## ORIGINATION FORM

Proposed Revisions to a Standard Plans Index  
(Please provide all information — Incomplete forms will be returned)

Index Number: 700-101  
Sheet Number (s): 1 of 1  
Index Title: Typical Sections for Placement of Single and Multi-Column Signs

**CASE VIII**

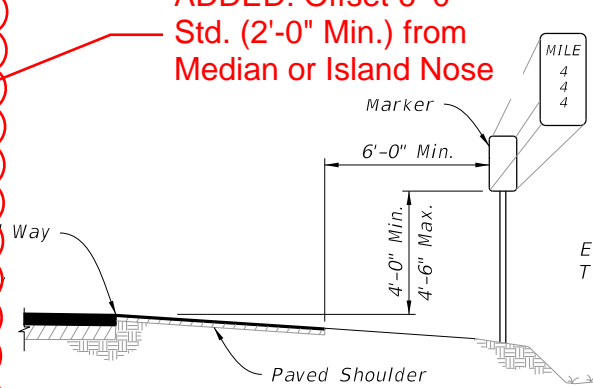
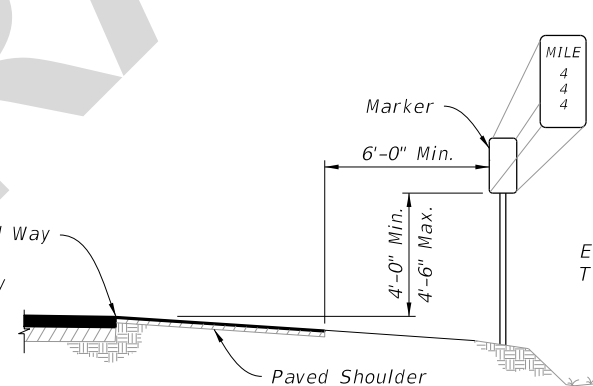
Added offset from median or Island nose to Case VIII Detail.

Request came from District 4 to standardize the 6' offset from median nose, which they have tried to implement as a D4 practice.

\* For separators <6'-0", center the sign within the separator, center sign column on island  
\*\* Added note

**ADDED: Offset 6'-0" Std. (2'-0" Min.) from Median or Island Nose**
